ADDENDUM No. 2 **Issue Date: July 16, 2012**

Boone Hospital Center - Cafe
for
Boone Hospital Center
1600 East Broadway
Columbia, Missouri

BHC Project No. #10C0040302
SOA Project No. 1209

1 ADD 02 - CAFE - REFLECTED CEILING PLAN

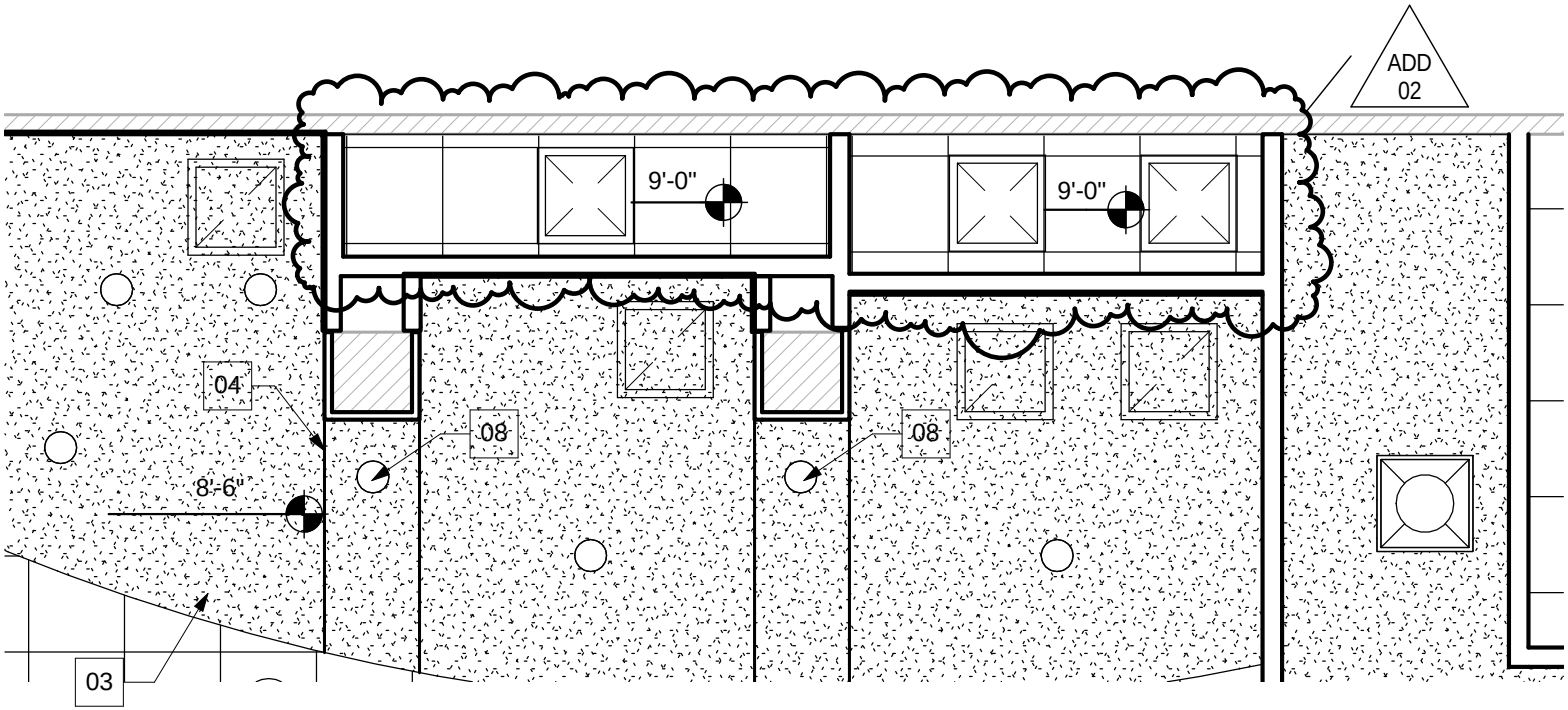
4) A201: FIRST FLOOR PLAN AND REFLECTED CEILING PLAN: Acoustical Ceiling Tile (AC-2) has been added to Storage Room 103 and Storage Room 104. Refer to the attached 8 ½ x 11 sheet

ELECTRICAL POWER AND SYSTEMS PLAN - RENOVATION

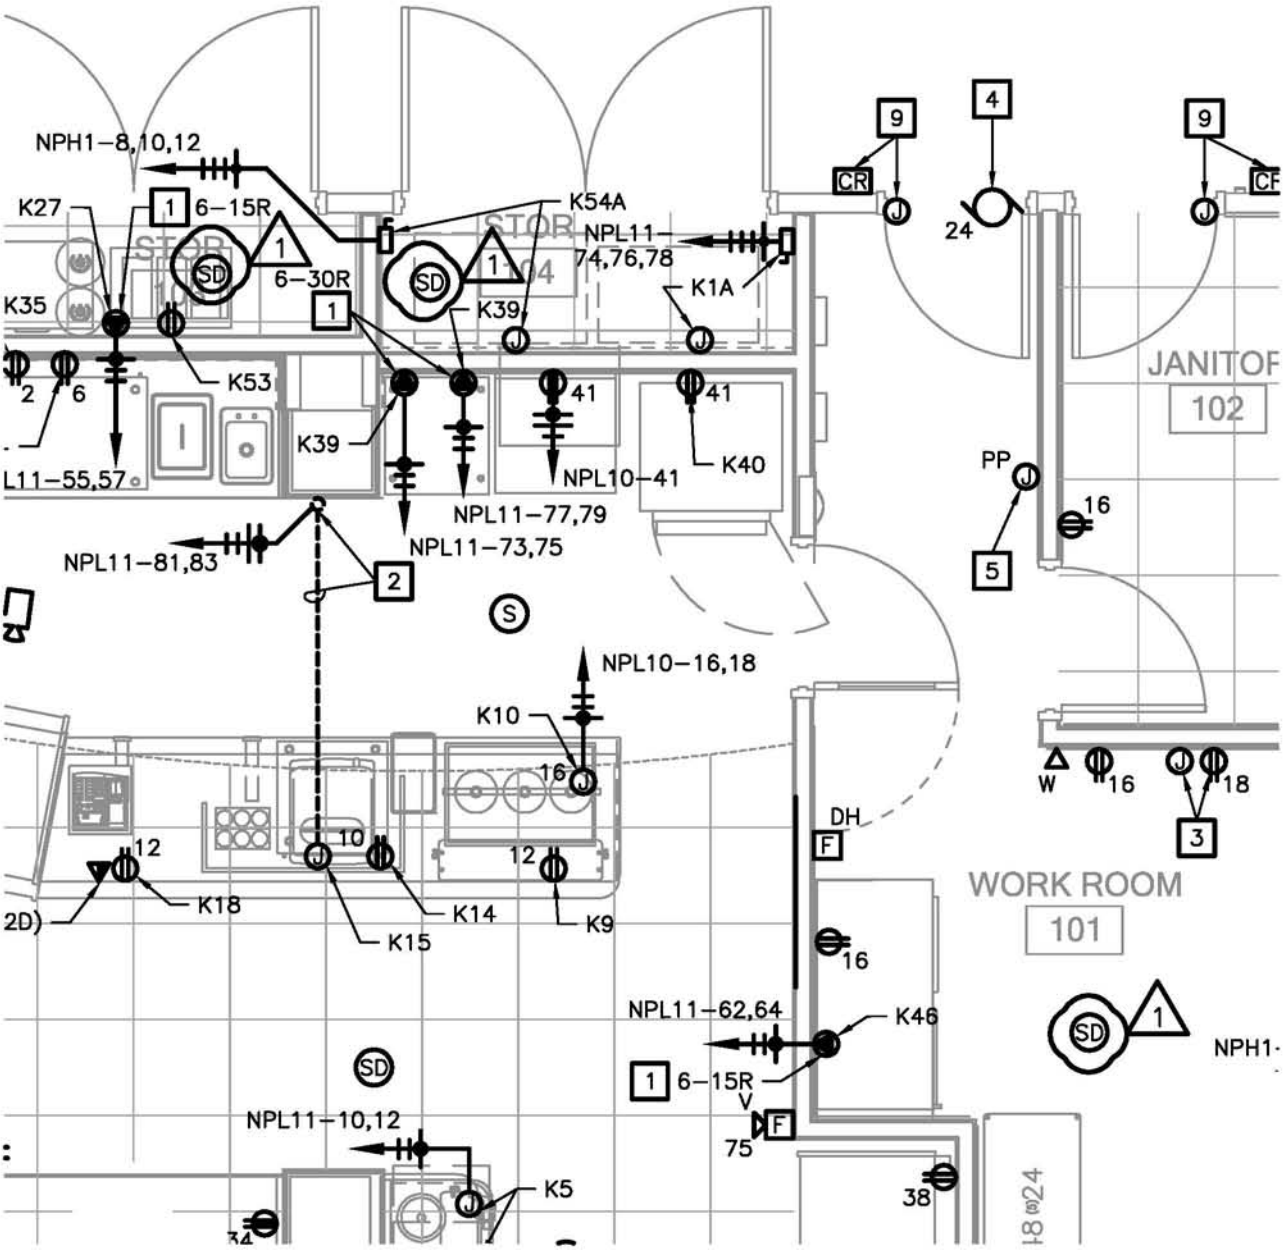
b) Add ceiling mounted smoke detector in Storage 103, Storage 104 and Work Room 101. Refer to the attached 8 ½ x 11 sheet.
